ALERT SERVICE BULLETIN
Bell Helicopter **TEXTRON**

NO. 206L-04-131

MODEL AFFECTED: 206L-SERIES

SUBJECT: TAIL ROTOR BLADE 206-016-201-131, CHECK AND REMOVAL FROM SERVICE OF.

Figure 1. Inspect the doubler for edge void on both sides of the blade

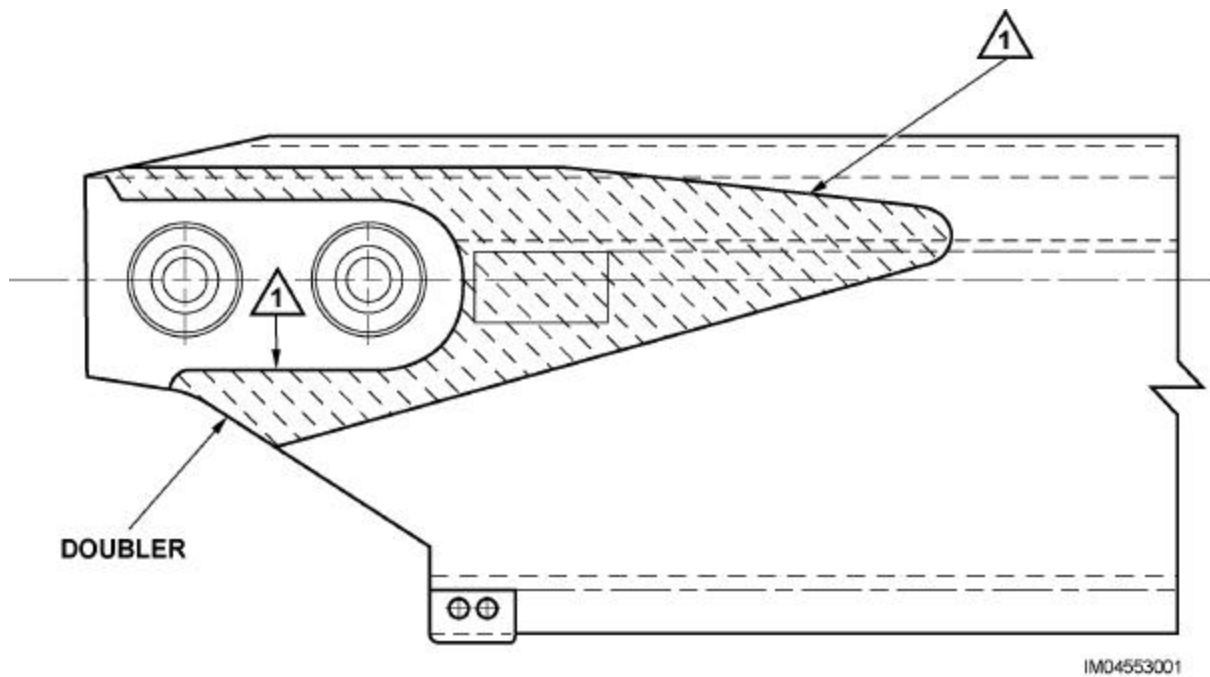
1. Use detergent (C-318) and thoroughly clean the area to be checked on both sides of the blade. Refer to figure 1.
2. Check both sides of the blade at the area indicated on figure 1 as follows:
 - a. Visually inspect the doubler for edge void on both sides of the blade.
 - b. If void or de-bonding is found, remove the blade from service immediately.
3. If no void or de-bonding is found, the blade is serviceable continue Part I until Part II is completed.
4. Make log book entries to show that the PART I of this Alert Service Bulletin has been accomplished.

Inspect the doubler for edge void or evidence of de-bonding on both sides of the blade.
